PLANS FOR THE CONSTRUCTION OF
 PAVING, BRIDGE, STORM SEWER, WATER, SANITARY SEWER
 SIGNALIZATION AND STREETScape IMPROVEMENTS FOR

ARAPAHO ROAD - PHASE III

FROM SURVEYOR BOULEVARD TO ADDISON ROAD

PROJECT RECORD COPY I

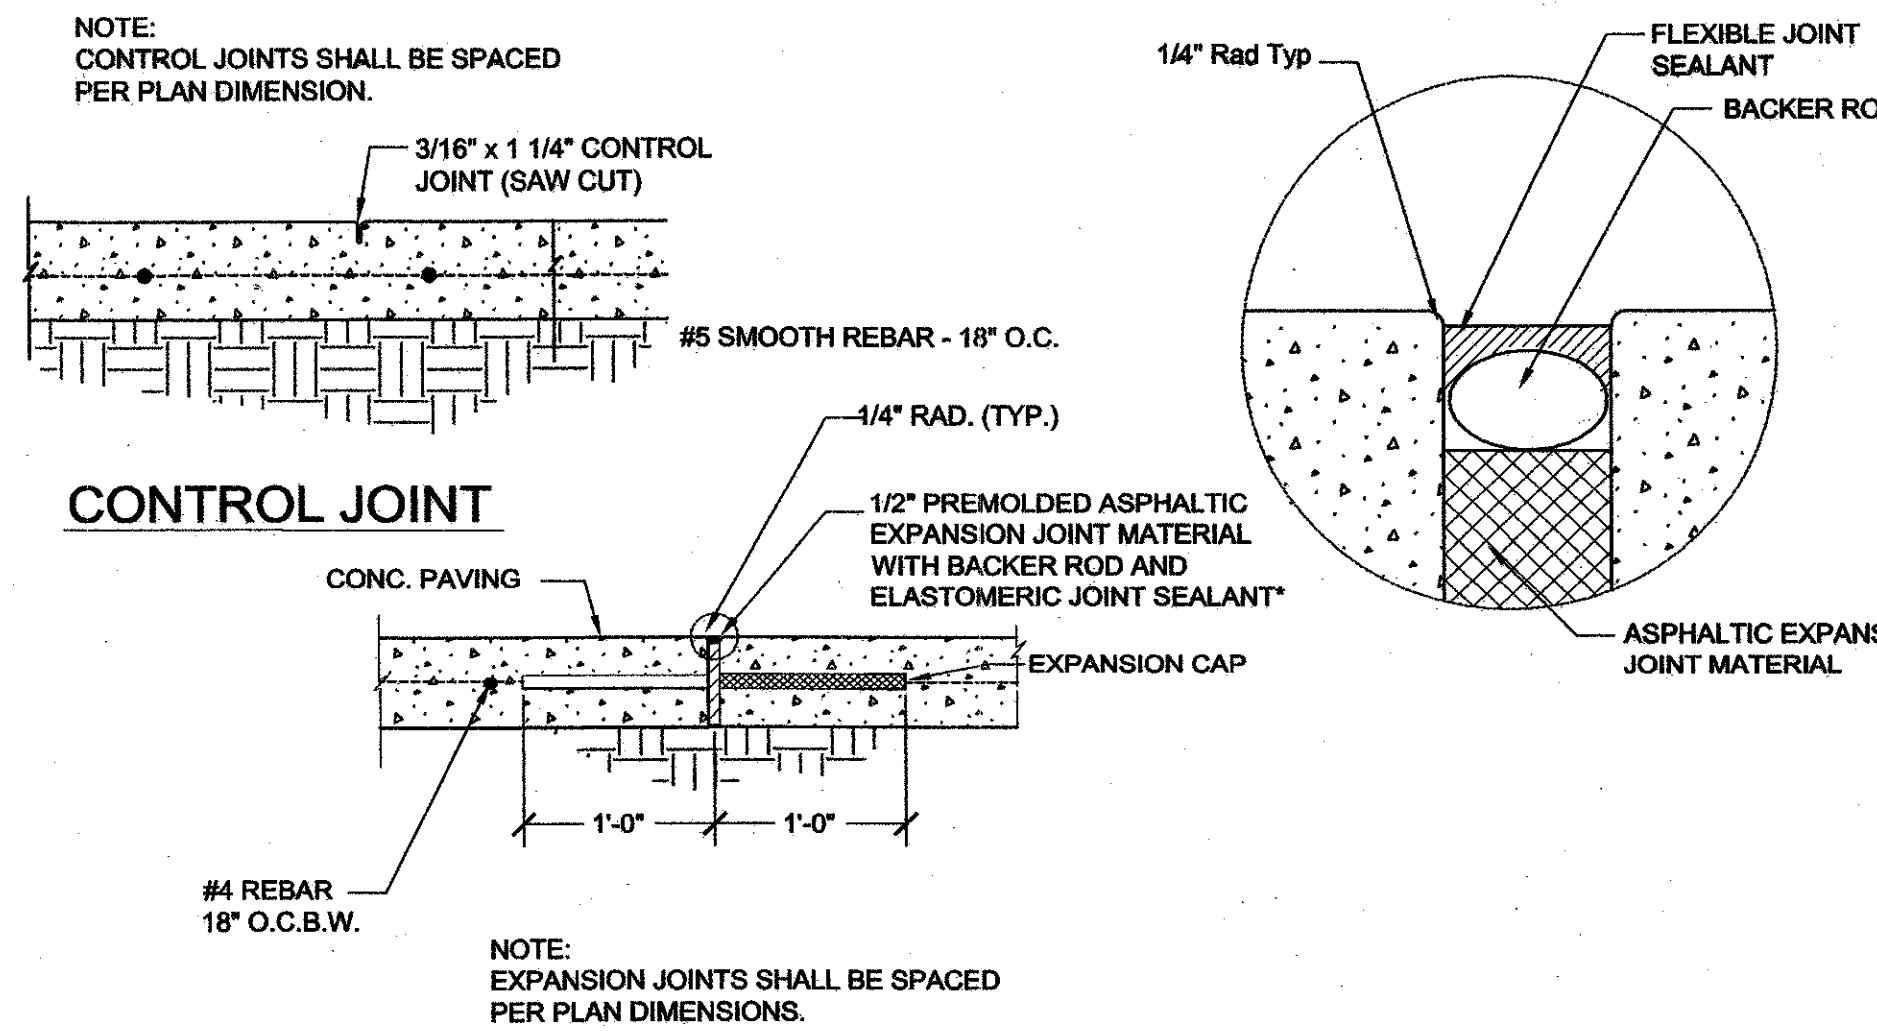
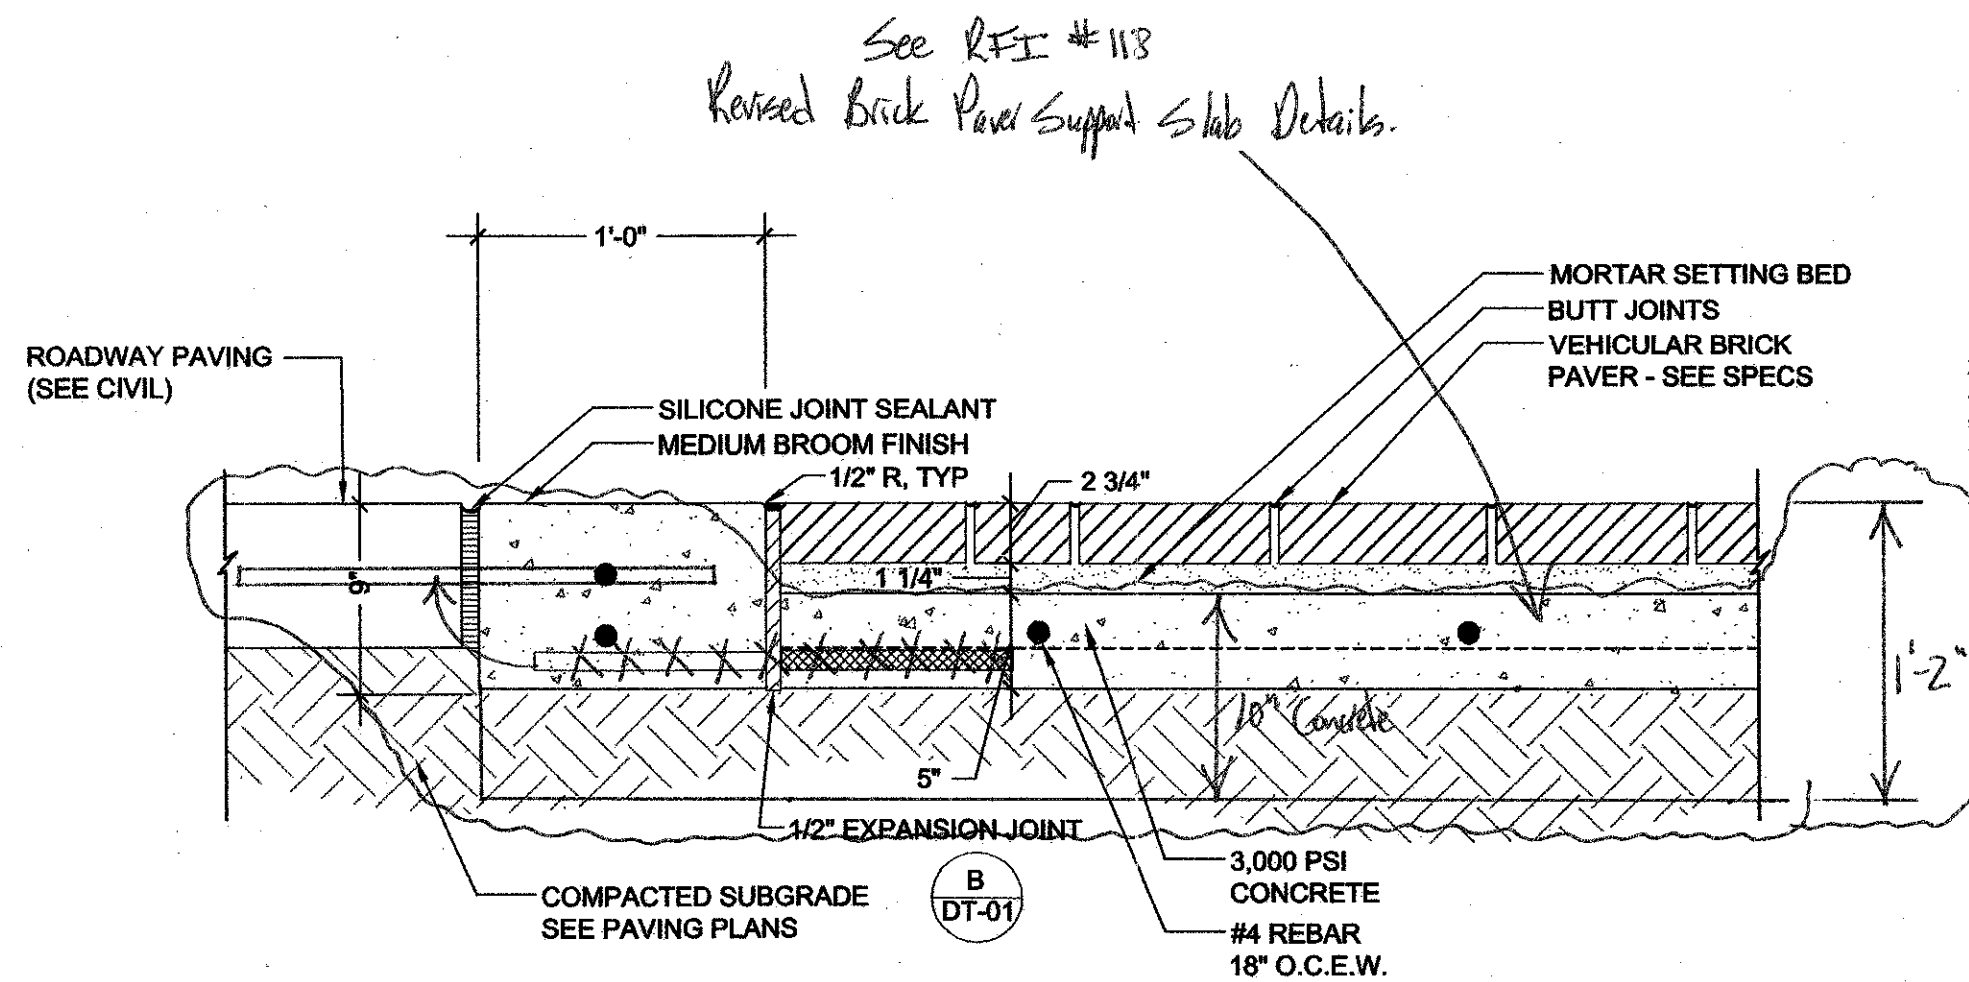
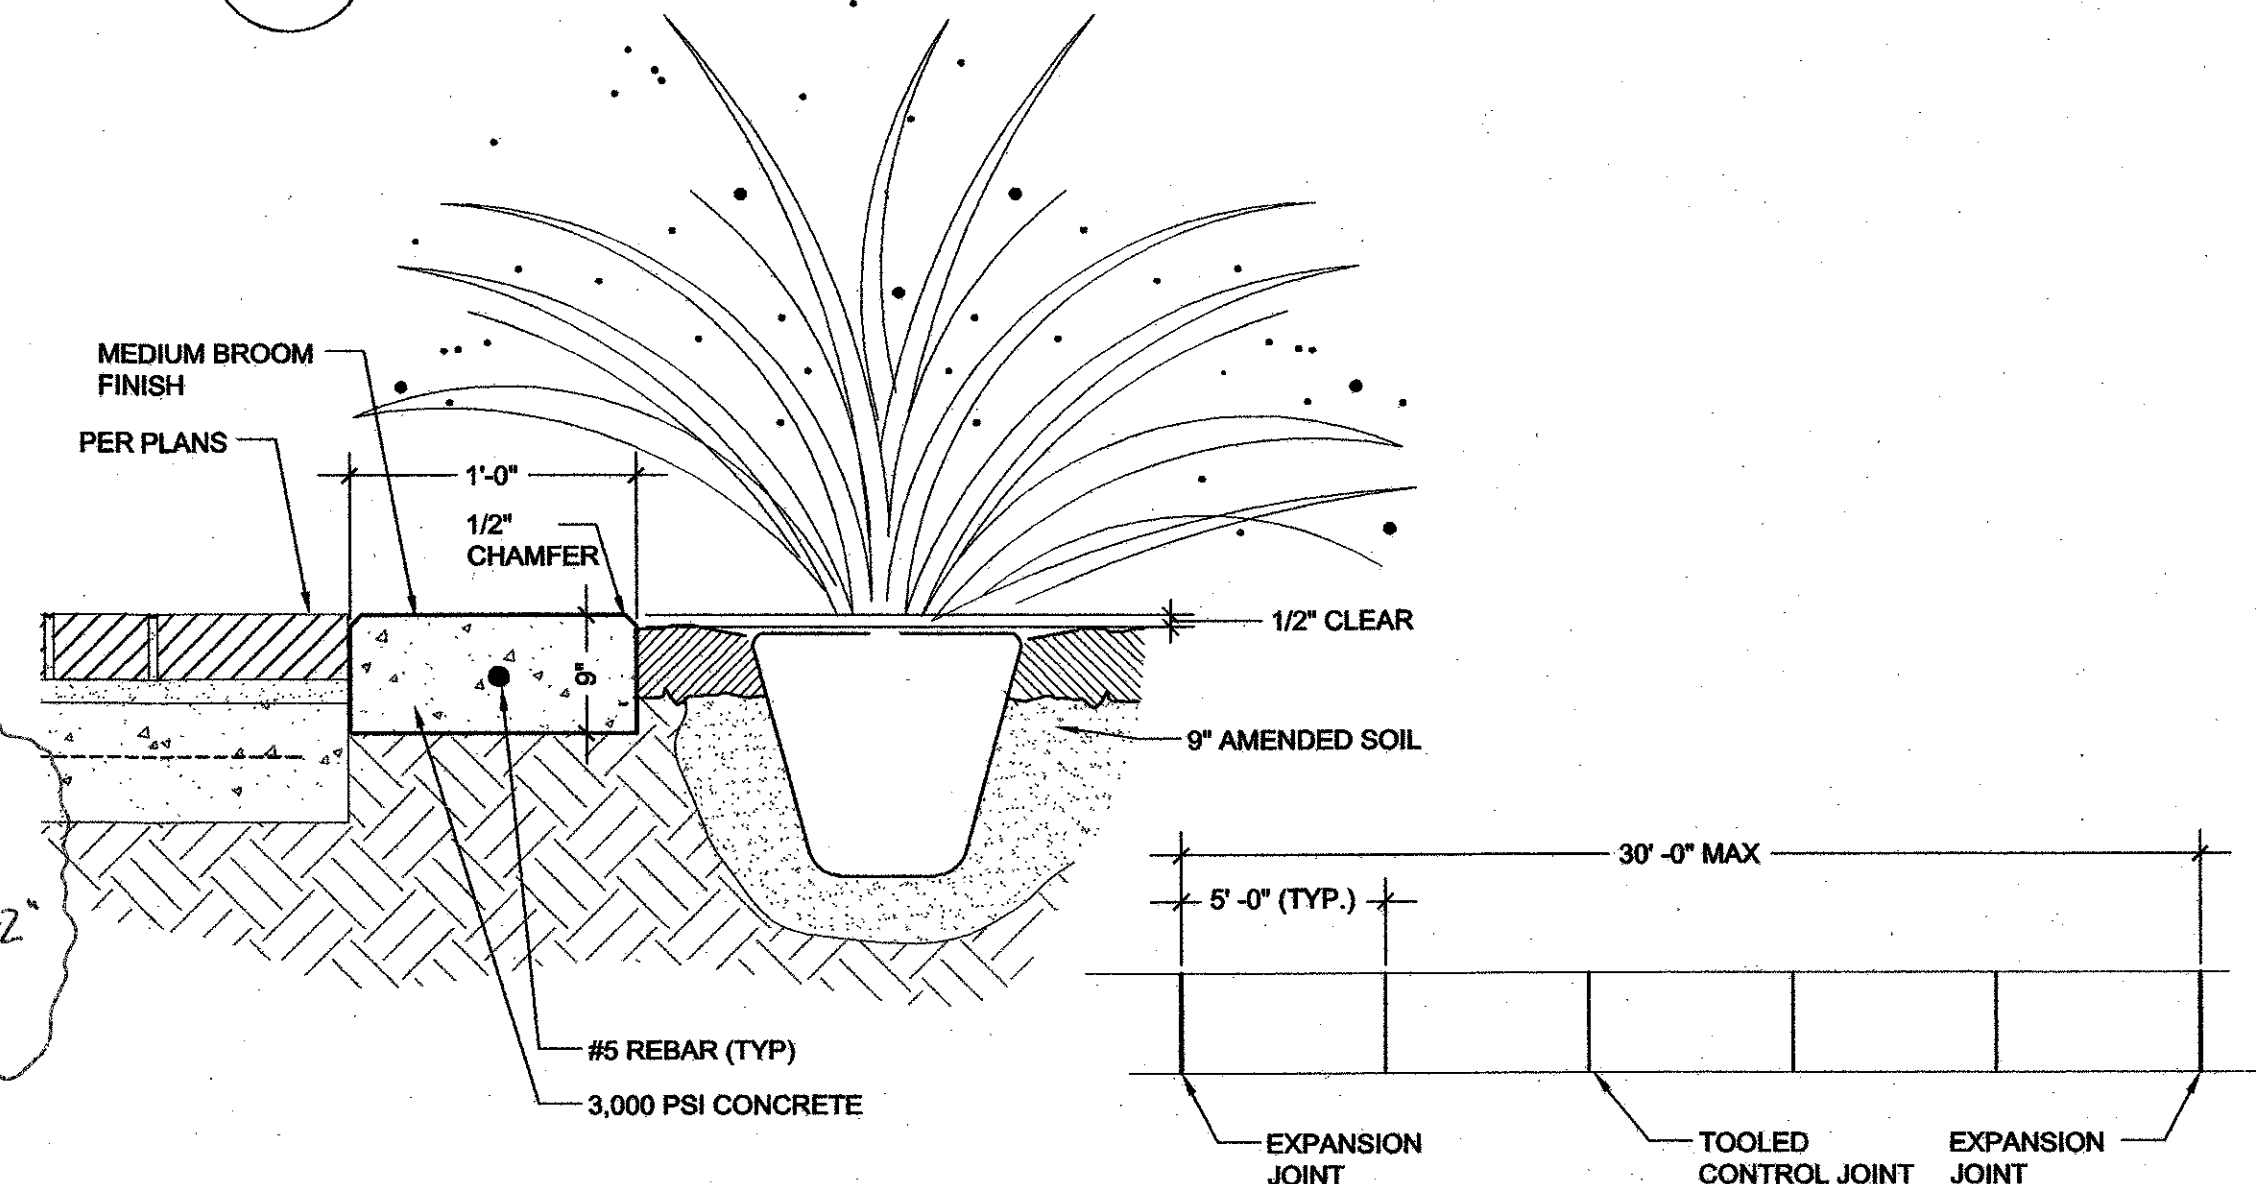
See RFI #118
Revised Brick Paver Support Slab Details.

See RFI #027
"Graded Riprap Detail"
The Graded Riprap shall be installed per TXDOT 1993, Section 432 - Graded Riprap Type Common. The "T" dimension shall be 12" thick.

D RECESSED TROUGH
DT-04

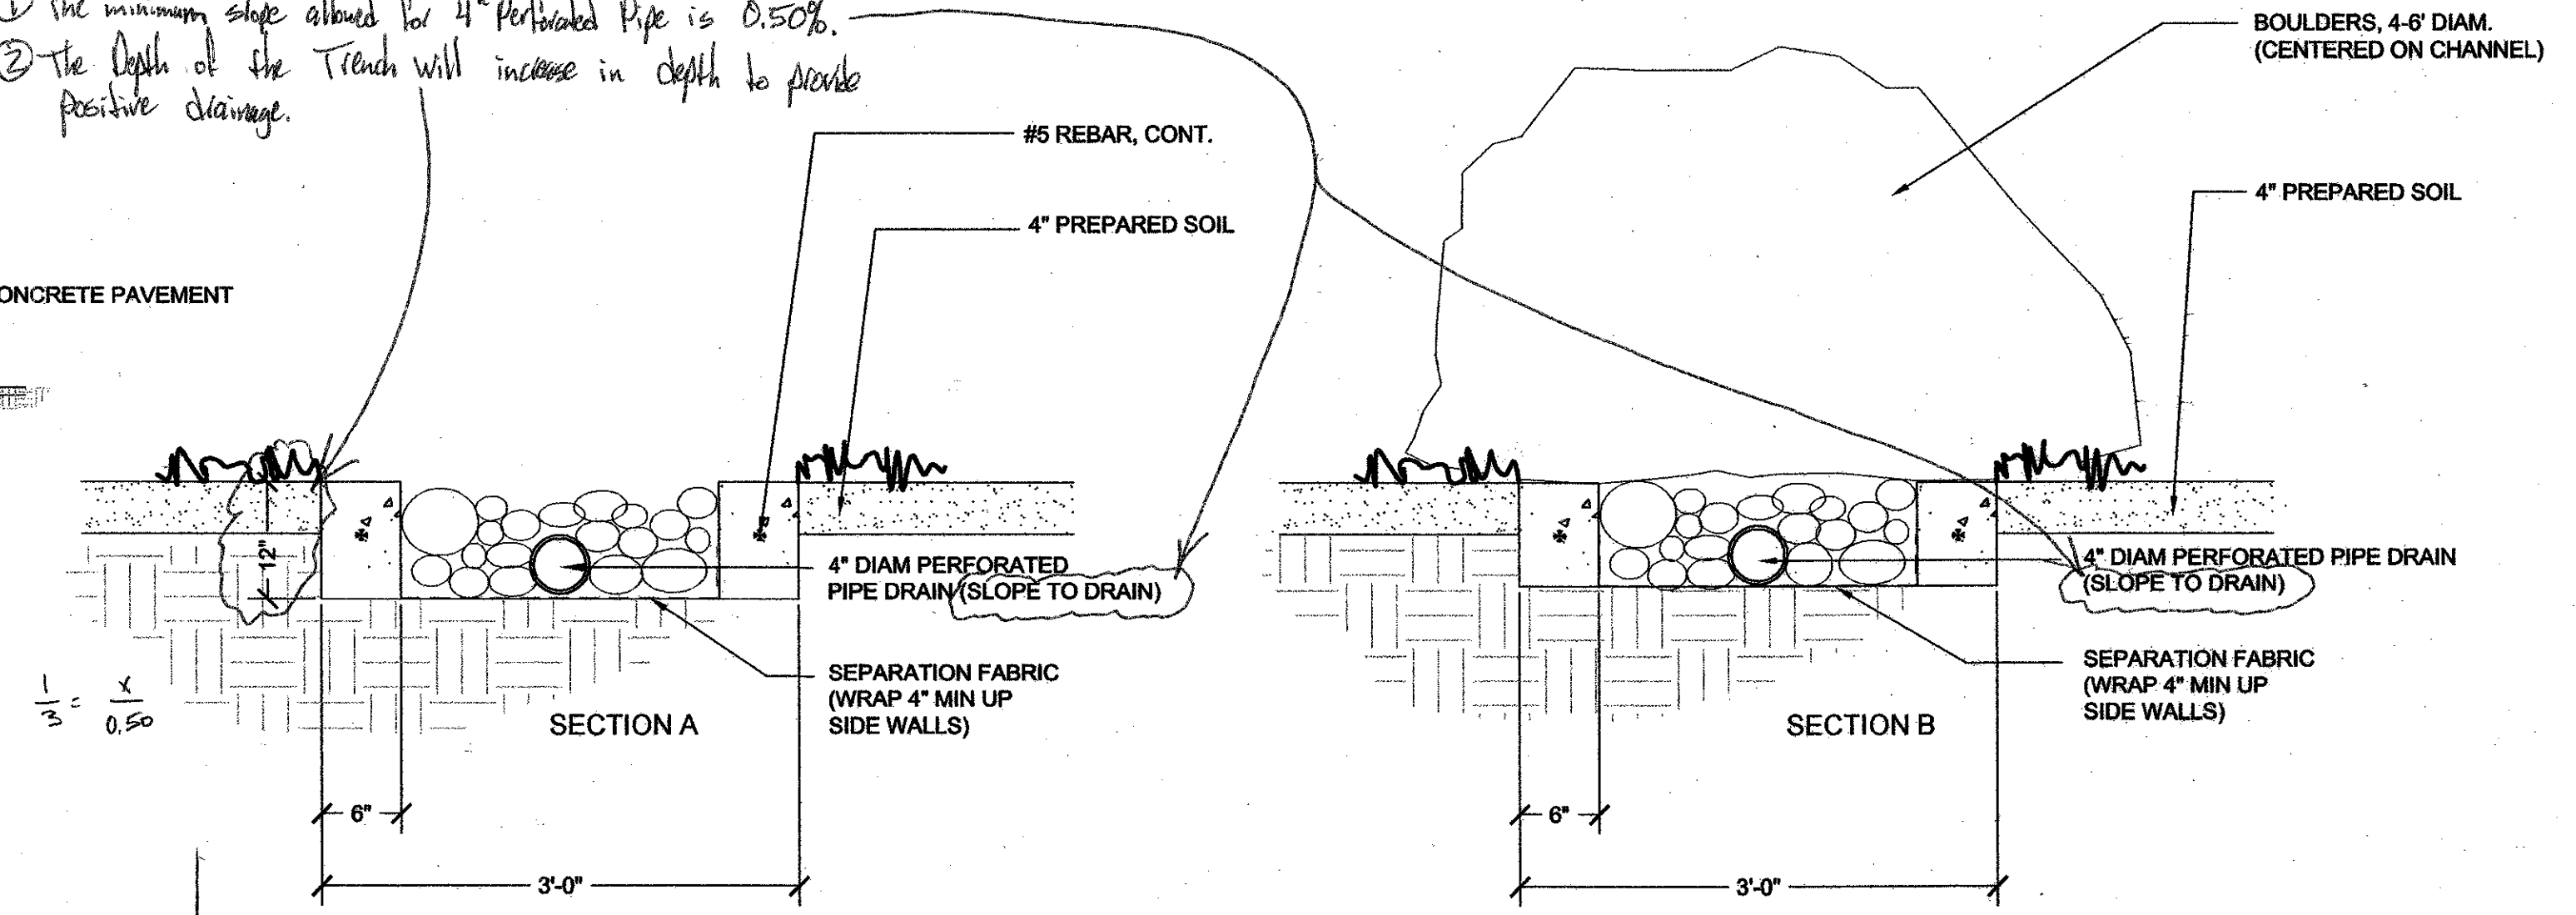
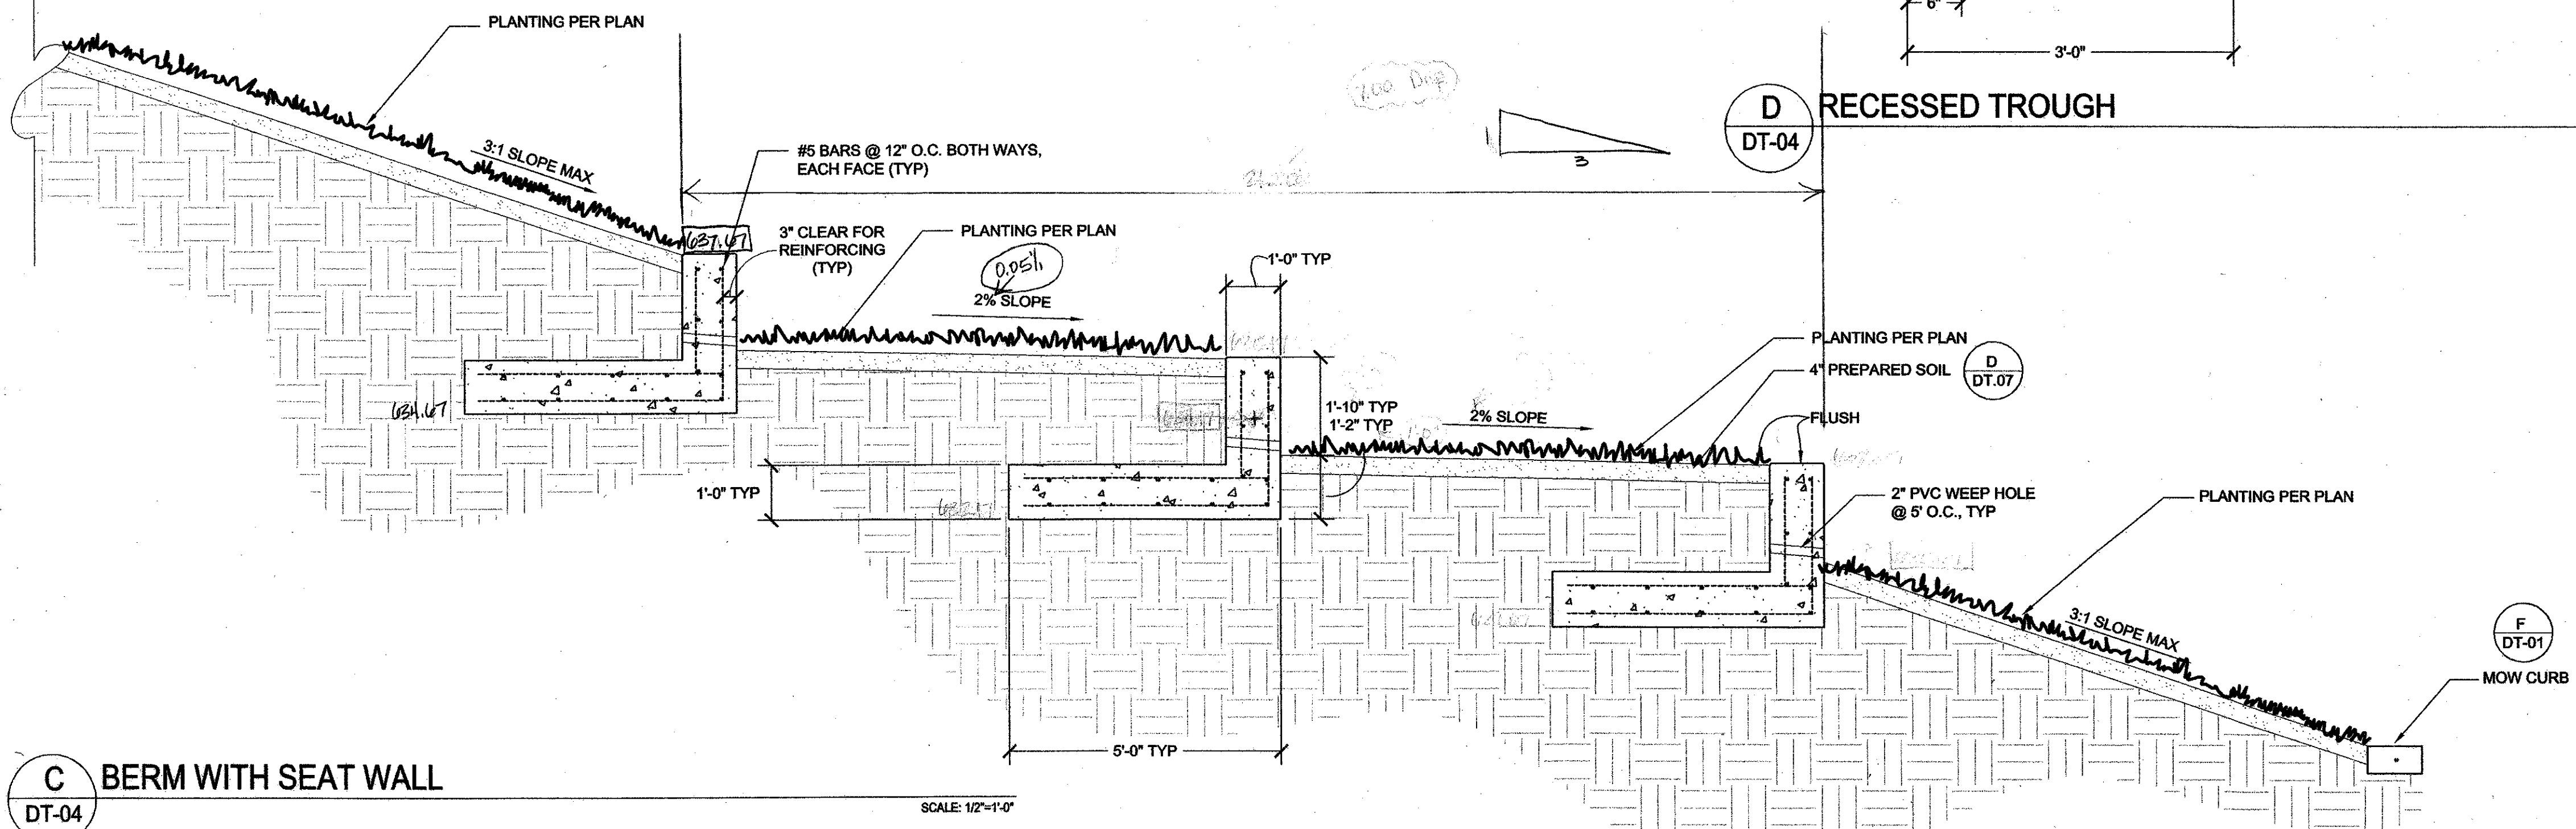
See RFI #084
 ① The minimum slope allowed for 4" Perforated Pipe is 0.50%.
 ② The depth of the Trench will increase in depth to provide positive drainage.
